Item Name: Replacement Skidtube

DRAWING NO. D2580	TITLE 205 SKIDTUBE ASSEMBLY	REV. E	DART AEROSPACE LTD ENGINEERING ORDER	D.E.O. NO. D2580-E-1	SHEET NO. SHEET 1 OF 1	SCALE NTS
DRAWN <i>UP</i>	CHECKED <i>ASS</i>	MFG. APPR. <i>ER</i>	APPROVED <i>[Signature]</i>	DE APPR. <i>[Signature]</i>		
DATE 11.12.13	DATE 11.12.13	DATE 11.12.13	DATE 11.12.13	DATE 11.12.13

PURPOSE:

CHANGE ALL C'BORED WELDED CROSSBOLT SPACERS TO SWAGED SPACERS

SECTION B-B, F-F, I-I
NOT TO SCALE

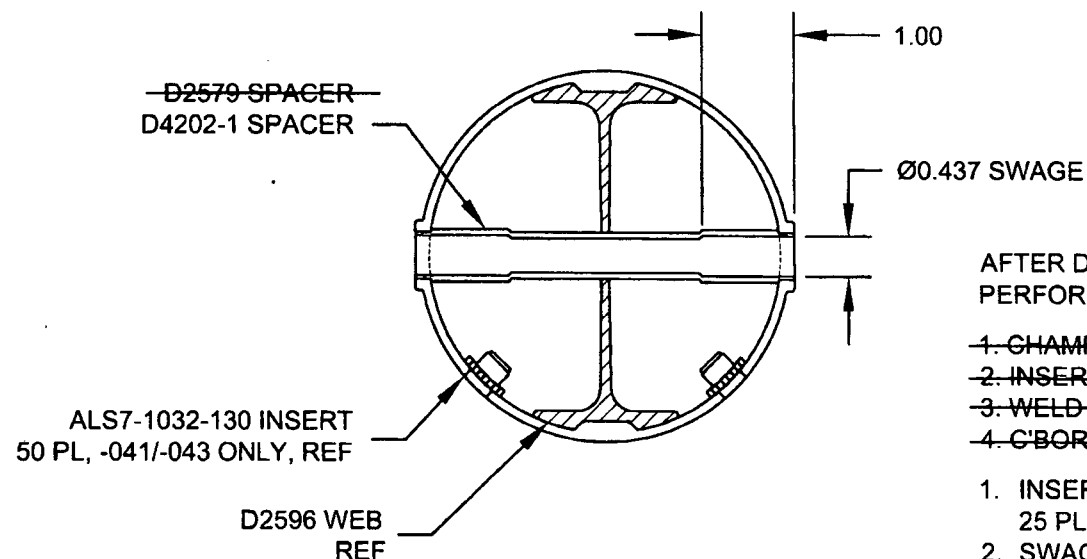
SECTION B-B, SECTION F-F, & SECTION I-I ARE AMENDED AS FOLLOWS
FOR ALL HOLES THAT WERE ORIGINALLY C'BORED:

*** FOR -045 SKIDTUBE ONLY:**

WELD 4X D2579 SPACERS PER DWG
IN LOCATIONS MARKED "NO C'BORE".
REF SHEET 4 OF DWG.

AFTER DRILLING AND BENDING ASSEMBLY
PERFORM THE FOLLOWING FOR Ø0.508 HOLES ONLY:

1. CHAMFER HOLE 0.060 X 45°
2. INSERT D2579 SPACER (20 PLACES)
3. WELD INTO PLACE AND GRIND FLUSH
4. C'BORE D2579 SPACER TO Ø0.437 X 1.00 DEEP

1. INSERT D4202-1 SPACER, 20 PL (-041) OR 20 PL (-045) OR 25 PL (-047)
2. SWAGE TO Ø0.437 X 1.00 DEEP PER QSI 002
3. TRIM / GRIND FLUSH PER QSI 002
